Attached please find the Bluewater Valley Downstream Alliance comments on the proposed change in radon monitoring sites at the Homestake Barrick Gold Uranium Mill Tailings site.

The Bluewater Valley Downstream Alliance (BVDA), a core member of the Multicultural Alliance for a Safe Environment (MASE), hereby submits the following comments regarding a proposed amendment to the radon monitoring program at the Homestake-Barrick Gold Uranium Mill Tailings site north of Milan, New Mexico. The proposed amendment was brought to BVDA/MASE attention via a letter from the NRC. No one from the NRC offered to meet with members of our community or offered to explain what this proposed change might mean for our community members, who have been living over 40 years now with radon in the ambient air that, according to a recent USEPA Human Health and Risk Assessment draft report, is five times the EPA limit and represents 18 times the EPA's acceptable lifetime cancer risk standards.

For the reasons given below, BVDA requests the NRC staff deny Homestake-Barrick Gold's (H-BG) application to change the location of its background radon monitor.

Figure 4-1 Predicted transport of on-site sources of radon normalized to HMC-4 and HMC-5 average

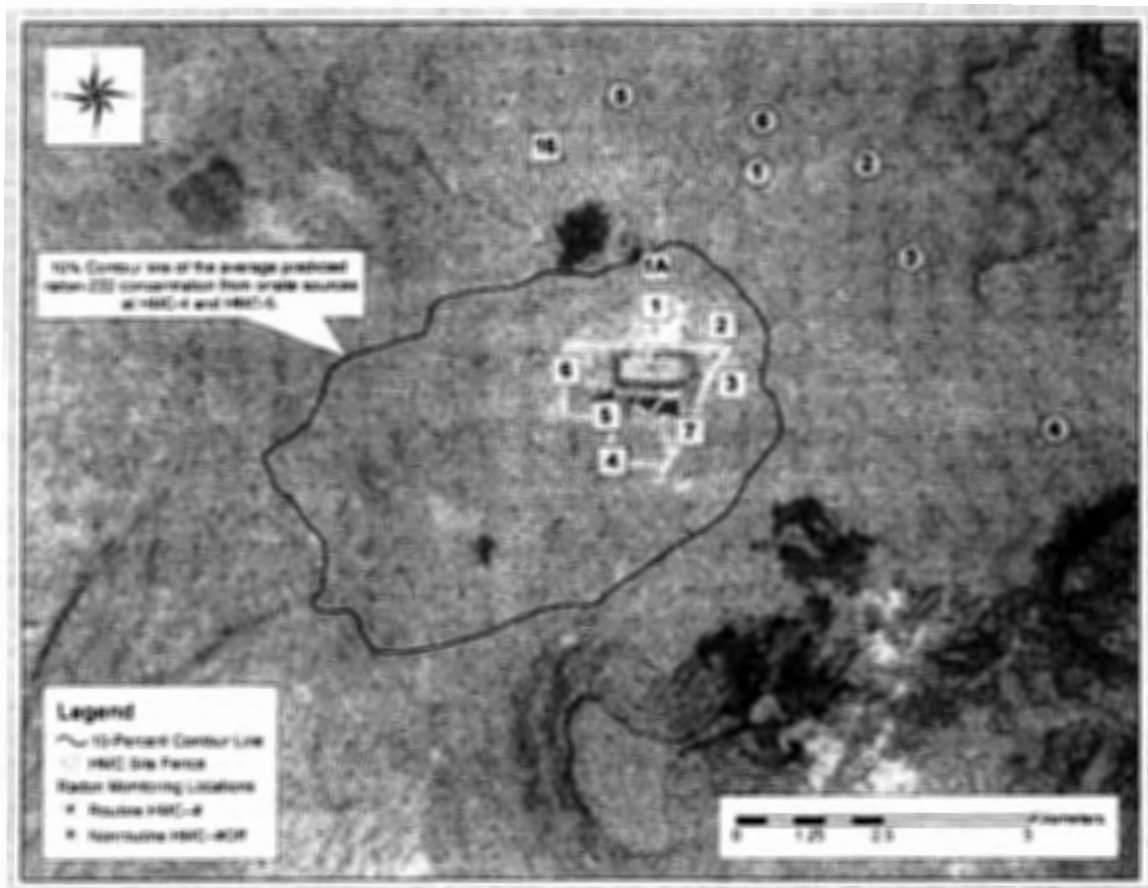
The amendment proposes to change the radon monitoring array used at the Homestake tailings site by replacing the radon monitoring site used as the baseline data source for NRC license purposes for more than two decades, named HMC-16, located about 3 miles north-northwest of the tailings, with a radon monitoring site located about 2 miles east of HMC-16 (“16” in “green square”) and about 2 miles north-northeast of the large tailings pile, named HMC-10ff (“1” in “blue circle”) as shown in the figure below.

In brief, H-BG’s Analysis supporting this proposed change asserts that HMC-16 may “underestimate background” and HMC-10ff would not.

Table 4.2 of the HMC consultants' report shows that Rn levels at location HMC-10ff are as high as ambient levels at the two monitors closest to the community -- HMC-4 and HMC-5 -- which, historically, have had the highest levels and therefore demonstrate substantial lung exposure risks to the people living closest to the large tailings pile. The consultants' report presents no data on soil uranium or radon levels at the HMC-10ff location. Wind rose patterns in the consultants' report, presented previously by Homestake-Barrick Gold, clearly show that the 10ff site would be in the direction of the most frequent winds, on the order of 8% to 10% of the time.
